Comment Resolution for Annex 120G Topics

Matt Brown, Huawei, 802.3ck Editor-in-Chief

Figure 120F–3—Transmitter equalizer functional model

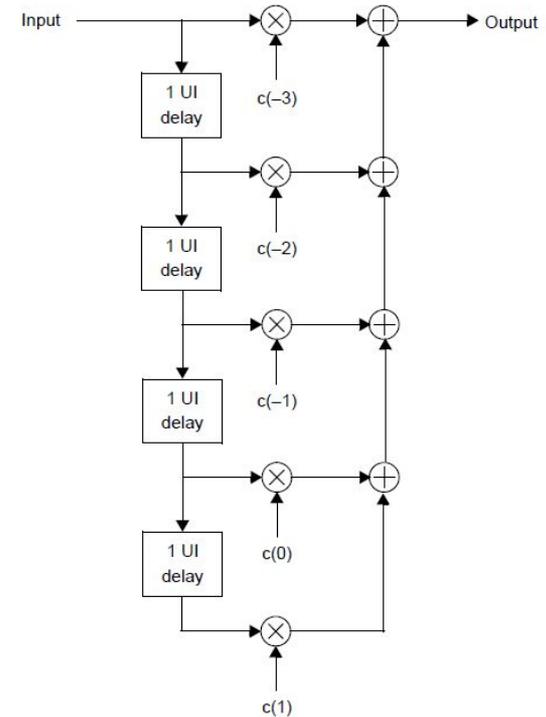
For module output, the optimum setting for the second precursor is 0.02 to 0.04, so the optimum for any third precursor would be less than 1/2 a COM step of 0.02. We can simplify the tuning challenge for real modules and stressed signal generators by removing clutter. 120G has 4 dB more headline loss than 120F and a module doesn't have the very large package loss that 120F may have, so it may be reasonable that 120F has a small c(-3) term when C2M host stressed input doesn't need it.

Change "The pattern generator output equalization functional behavior is equivalent to the model shown in Table 120F-3. The tap coefficients are not specified" to "The pattern generator output equalization functional behavior is equivalent to the model shown in Table 120F-3, with c(-3) always zero. Other tap coefficients are not specified".

Unless the extra loss in the module stressed input signal tips makes this tap significant, this can apply to 120G.3.4.3.1 also.

PROPOSED REJECT.

A straw poll, also recorded in the comment response to i-192, indicated clear consensus to make no changes to the output equalizer c(-3) tap.
